SEWAGE-DISPOSAL SYSTEM

MARYLAND STATE DEPARTMENT OF HEALTH

SUBDIVISION Brighton Pines ROAD 1383³ Lakeside Drive LOT 16, Sec.1, Area 2

PROPERTY OWNER Joseph and Rochelle Long

INDICATE NORTH — NAME ADJOINING ROADWAY AS BASE LINE

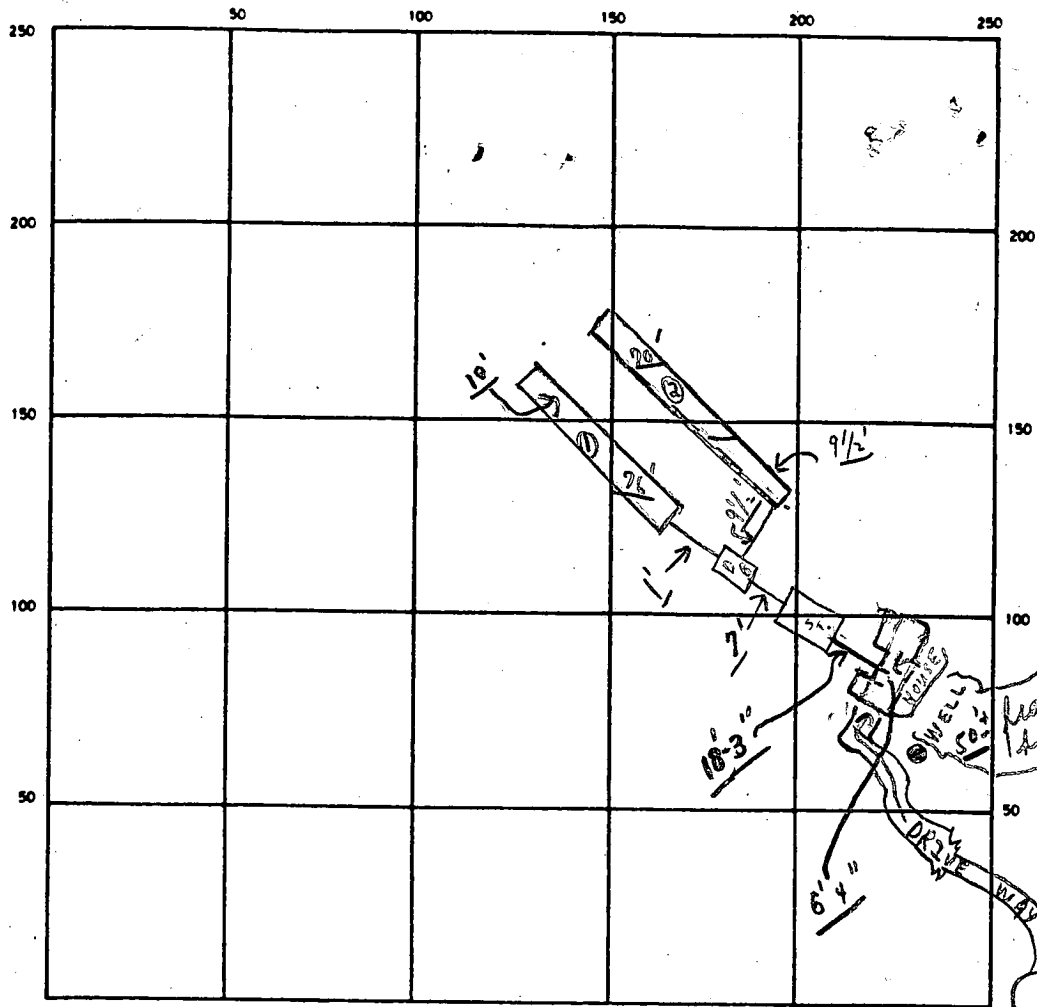
SEPTIC TANK LEVEL OK CLEANOUTS OK

DISTRIBUTION BOX LEVEL OK (Baffles is in)

DRAIN FIELD/TILE FIELD DEPTH 9' FT. TRENCH WIDTH 2 FT. INLET DEPTH 4 FT.

EFFECTIVE GRAVEL DEPTH 5' FT. TOTAL LENGTH $\left. \begin{matrix} \textcircled{1} 26' \\ \textcircled{2} 20' \end{matrix} \right\} 146$ FT

NUMBER OF TRENCHES 2 ONE SIDEWALL/BOTTOM AREA 730⁺ SQ FT.

REMARKS 12/29/89 Partial septic tank only; ok to
continue; $\textcircled{1}$ Partial $\textcircled{1}$ Trench being worked on + $\textcircled{2}$ trench
not dug; C.B.D - Note: trenches swing - to fill in as they go;
ok to cover $\textcircled{1}$ Trench only; $\textcircled{3}$ Partial ok. to cover all
work - need to see pipes from septic tank to house
wall only; C.B.D Hold trench depth 9' + as certified
